ABERDEEN MIDDLE SCHOOL
HVAC SYSTEMIC RENOVATION

ADDENDUM NO. 5

DATE: April 3, 2024

PROJECT: Aberdeen Middle School
HVAC Systemic Renovation
111 Mt. Royal Avenue
Aberdeen, Maryland 21001
Gipe Project No. 23043

LOWER LEVEL AREA E - NEW WORK

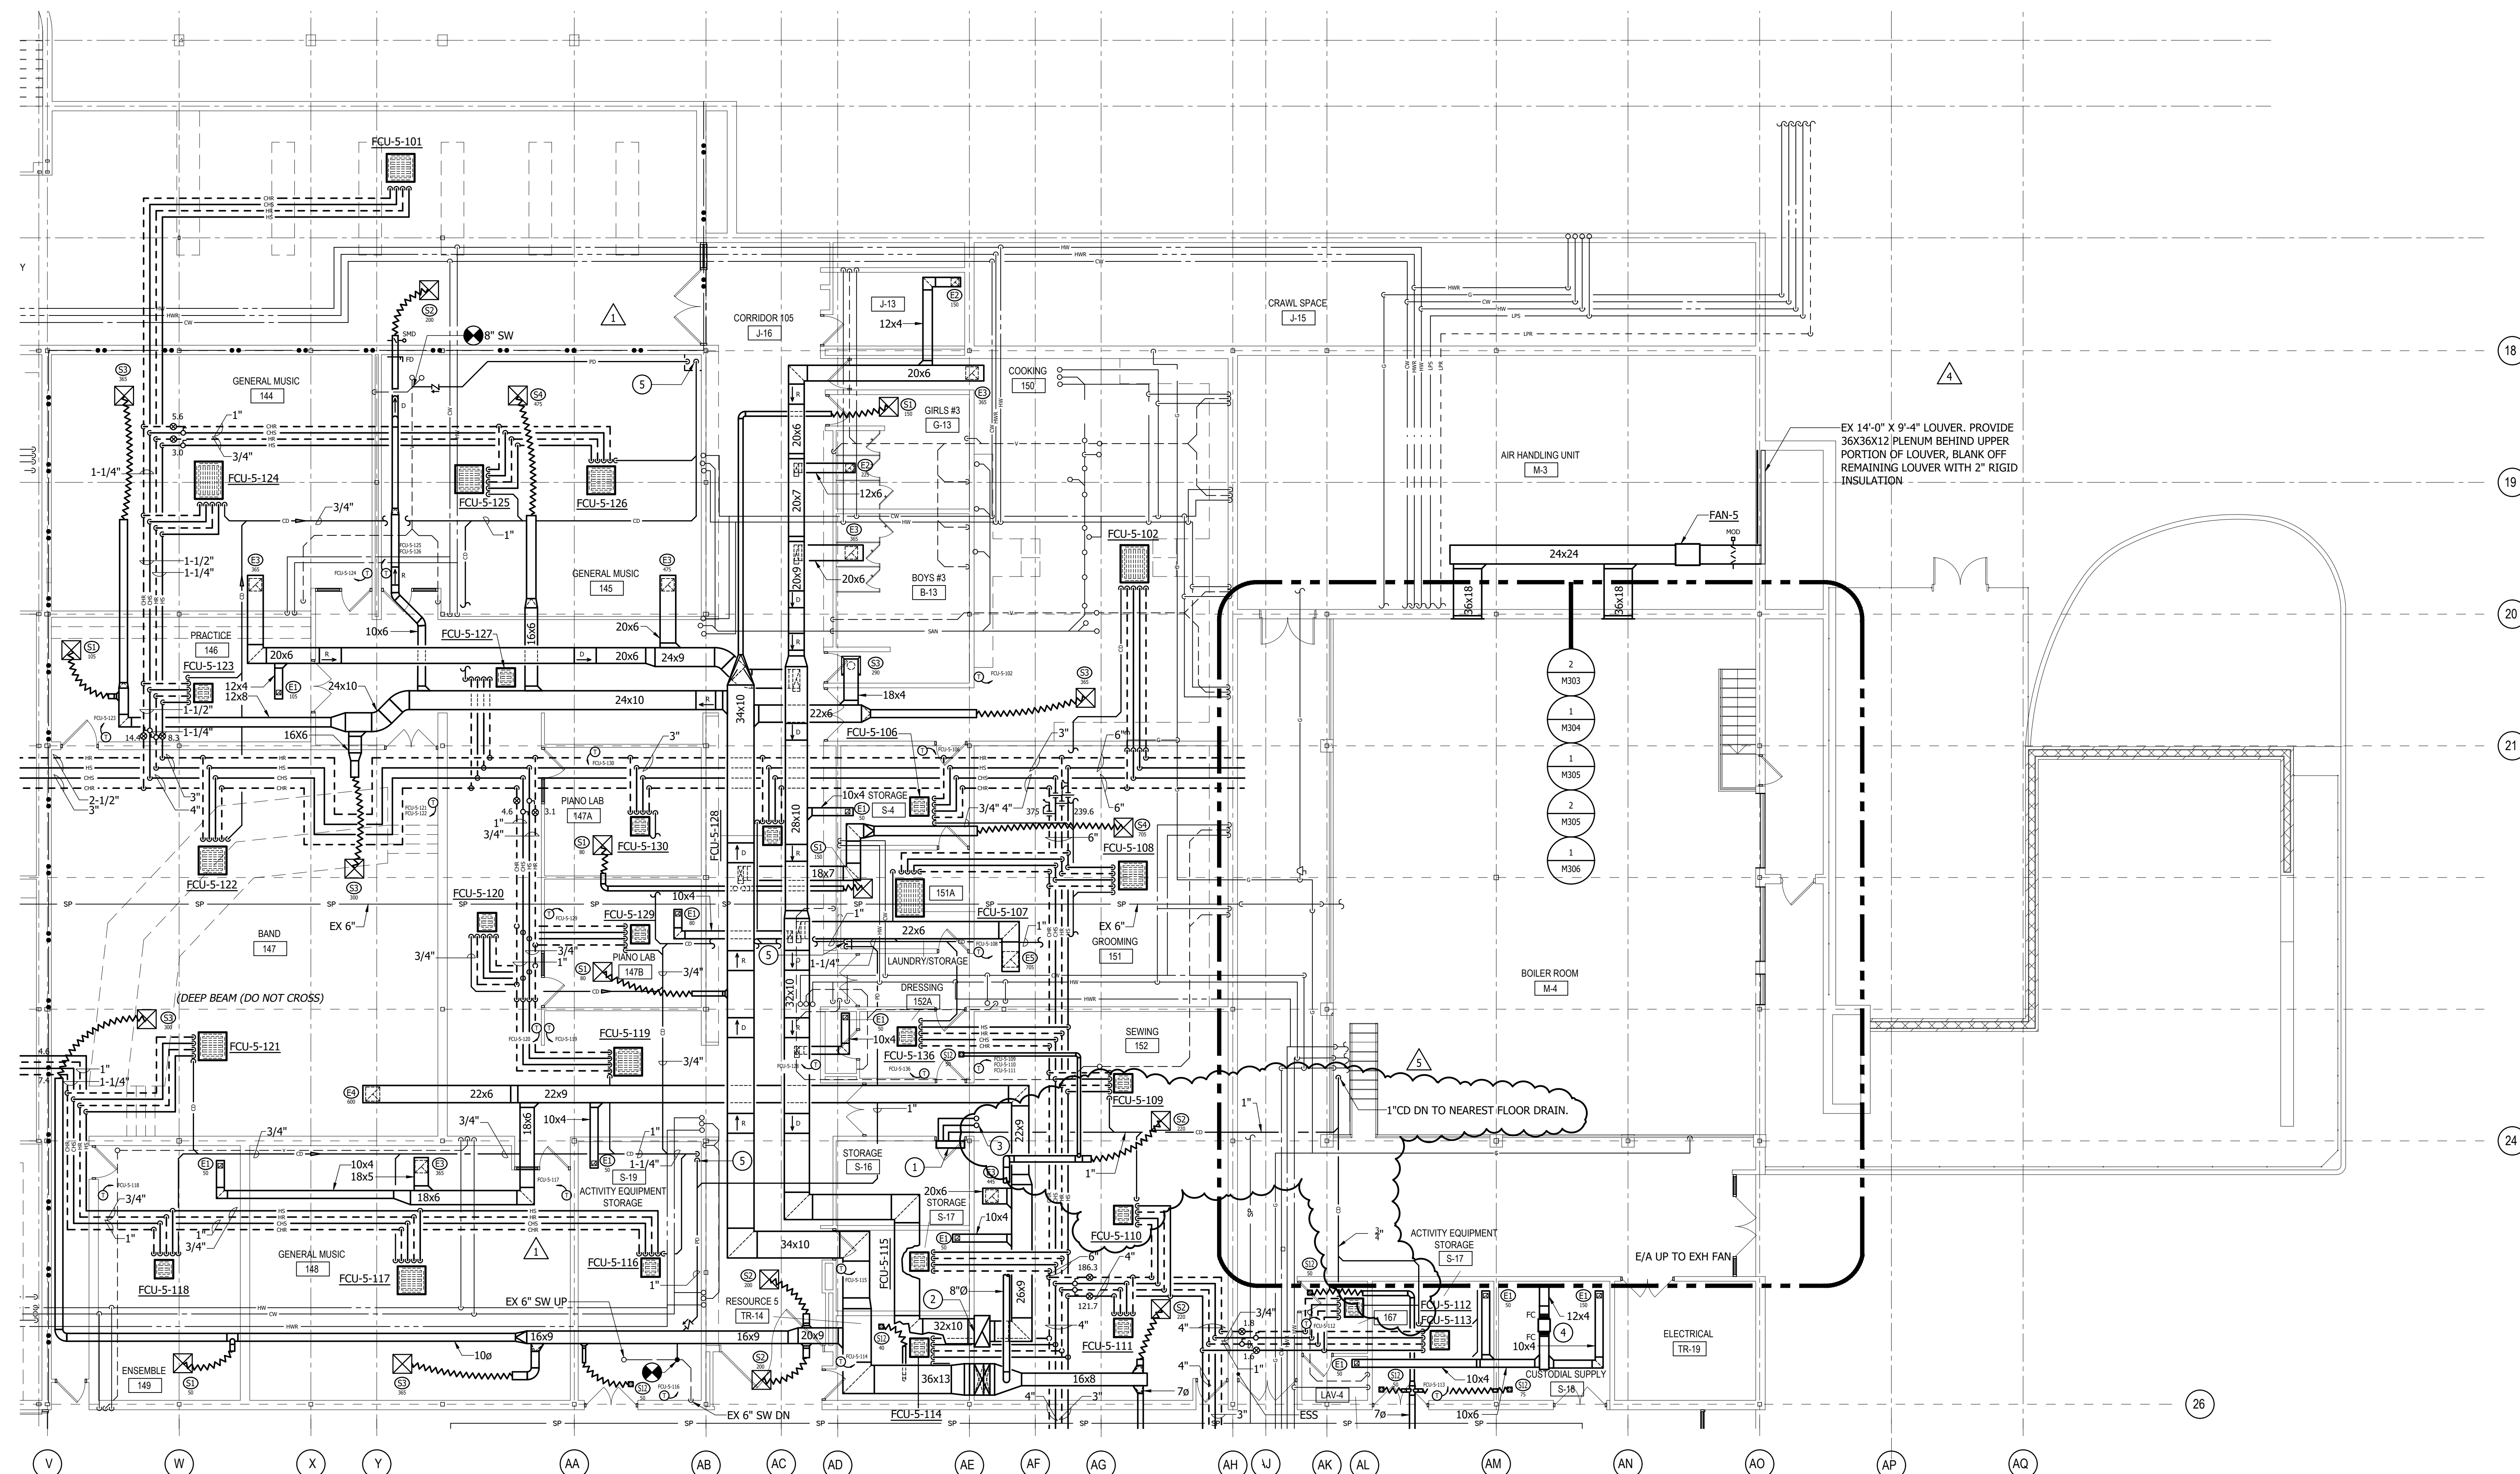
10. M203 – LOWER LEVEL AREA E – NEW WORK
See attached revised drawing.
11. **M206 – UPPER LEVEL AREA B – NEW WORK**
See attached revised drawing.
12. **M207 – UPPER LEVEL AREA C – NEW WORK**
Provide 4'X8' expansion loop in the HS/HR piping main just outside the Teachers Planning Room 22. Provide anchors and guides in accordance with ASHRAE.

1
M212
ROOF PLAN AREA B - NEW WORK
SCALE: 1/8" = 1'-0"

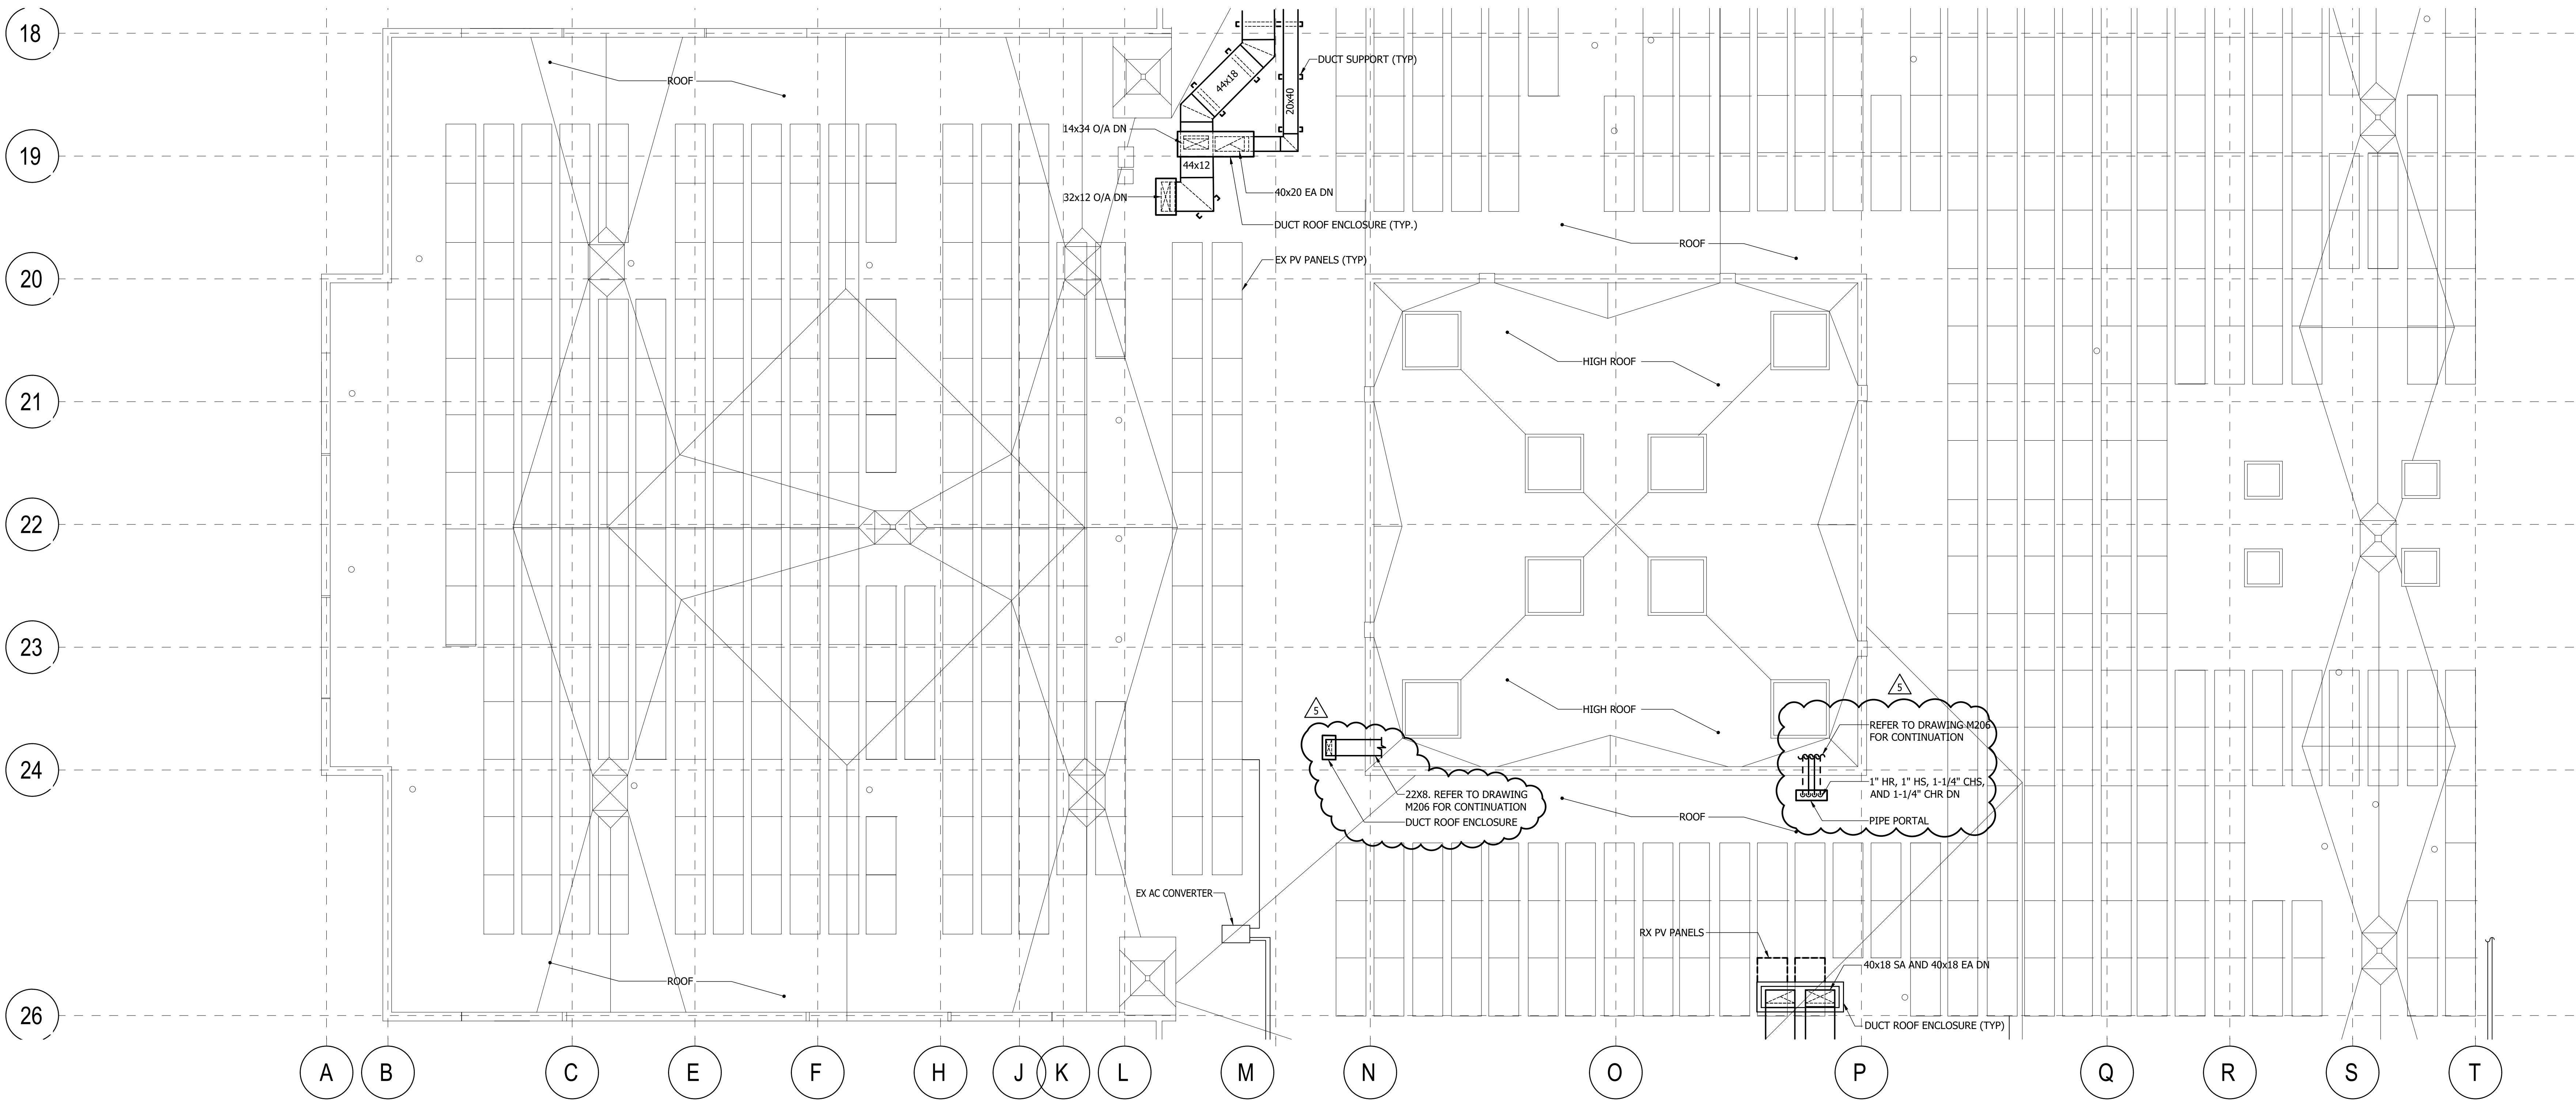
13. **M211, M212, M213, M215, M216 – Miscellaneous Roof Plans.**
Add the following General Note:
Where there are 4 or more duct supports in a row, the two duct supports between the two end supports (of a four support group) shall be a non-penetrating hot-dipped galvanized Unistrut type support with polycarbonate bases. The non-penetrating supports shall not be used at locations in change of direction. The manufacturer shall provide two rubber pads and they shall be used on the roof between the polycarbonate base and the existing roof membrane. Do not adhere to the existing roof membrane. Support shall be equal to Unistrut Service Company.

14. **M211 thru M216 – Miscellaneous Roof Plans**
Add the following General Note:
If the gypsum deck is not suitable to attached to then provide (2) 1/8-inch thick galvanized steel plates and through bolt the deck for the ductwork supports, equipment rails, pipe supports and portals, etc. One plate shall be on the upper

15. **M212 – ROOF PLAN – AREA B – NEW WORK**

See attached revised drawing.
